SI 2127
For technical personnel only!
1/2

ADAPTER CABLE 4.07360.53.0

**FOR REPLACING PREDECESSOR VERSIONS
WITH THE LATEST EXHAUST BACK PRESSURE SENSORS**

Adapter cable with accessories (item no. 4.07360.53.0)

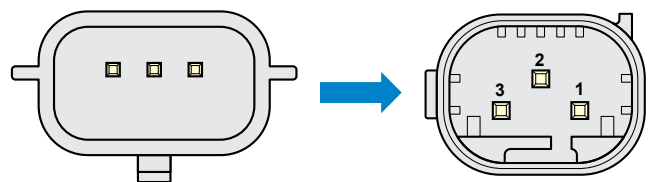
The exhaust back pressure sensor with ref. no. 22 36 517 19R has been discontinued. This sensor was used in Renault engines. In some cases, the affected engines were also installed in Mercedes-Benz, Nissan and Dacia vehicles (see table on the back). As OE, the exhaust back pressure sensor has been replaced with a sensor that has a different connector plug. As a result, if this old, discontinued sensor fails, the original plug must be removed and replaced with a suitable one.

To make it easier to replace the part, Motorservice offers the adapter cable 4.07360.53.0, which enables the discontinued exhaust back pressure sensor to be easily replaced with the suitable model 7.12061.00.0 from Pierburg.

Conversion measure

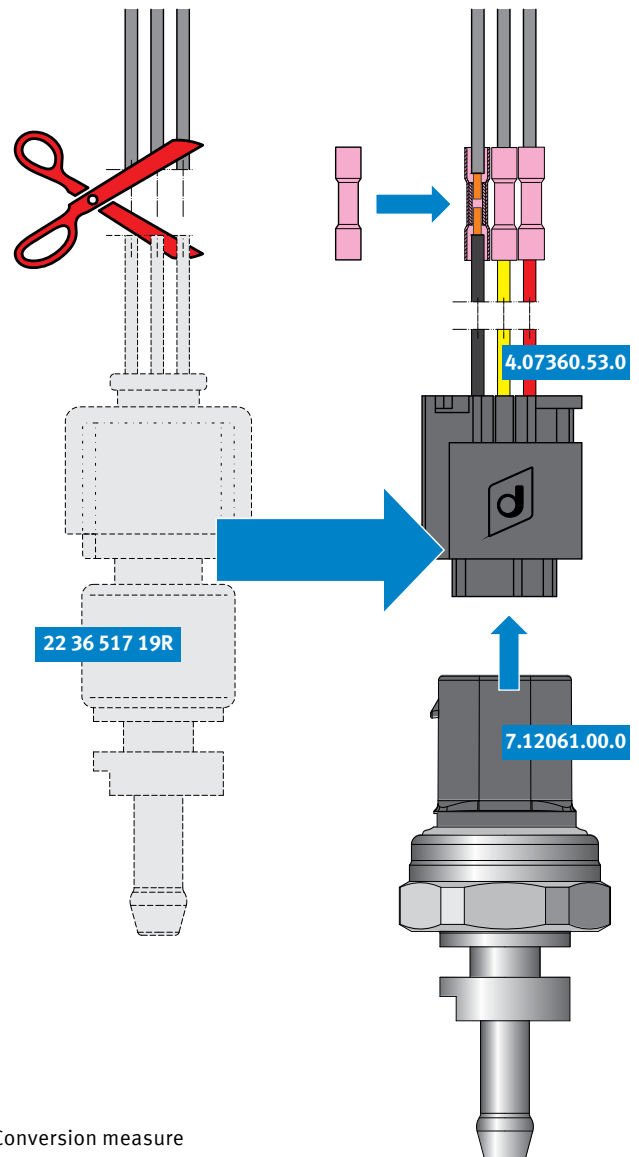
- Cut off the old sensor 223651719R close to the old plug.
- Connect the adapter cable 4.07360.53.0 using the shrink-fit connectors, making sure to observe the pin assignment.

- 01 Ground (red)
- 02 Signal output (yellow)
- 03 Supply voltage (black)
